Net Zero Teesside Project

Planning Inspectorate Reference: EN010103

Document Reference: 9.20 Applicants' response to Orsted Hornsea Project Four Ltd's Deadline 3 Submission

Mr Sewell's timeline for modelling and field studies is unrealistic

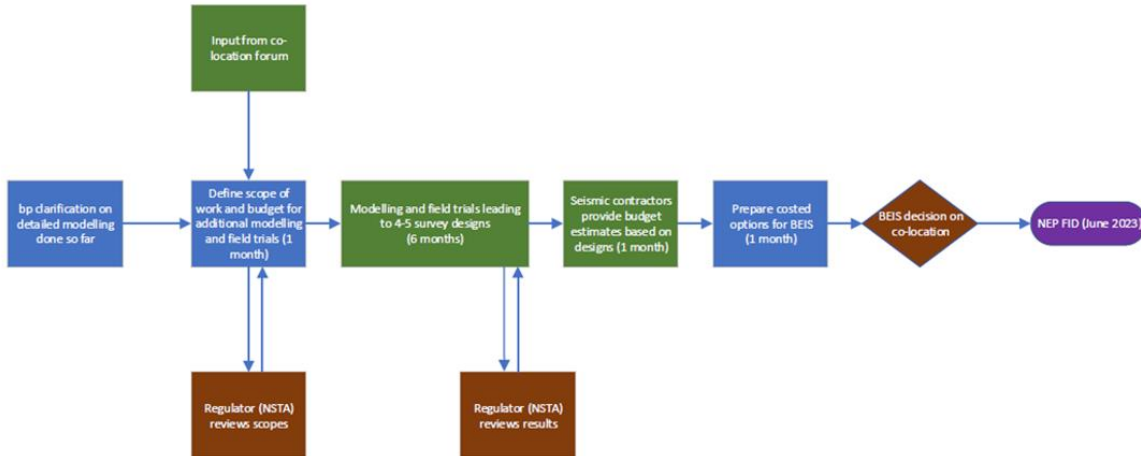
- 8.15 Mr Sewell sets out a flow chart in his Recommendations illustrating "*the process for how investigations could progress to enable a fully informed decision to be made on the feasibility of co-location from a seismic data acquisition perspective*". For ease of reference, we provide Mr Sewell's flow chart below.

- 8.16 It should be clear from our explanation of the complexity of modelling and field trials that it would be unrealistic even to conduct the necessary modelling and one single field study in the pre-FID period, let alone the pre-modelling field trial and post-modelling repeat field studies over a number of years which would be necessary to obtain the level of certainty which would be required by investors.
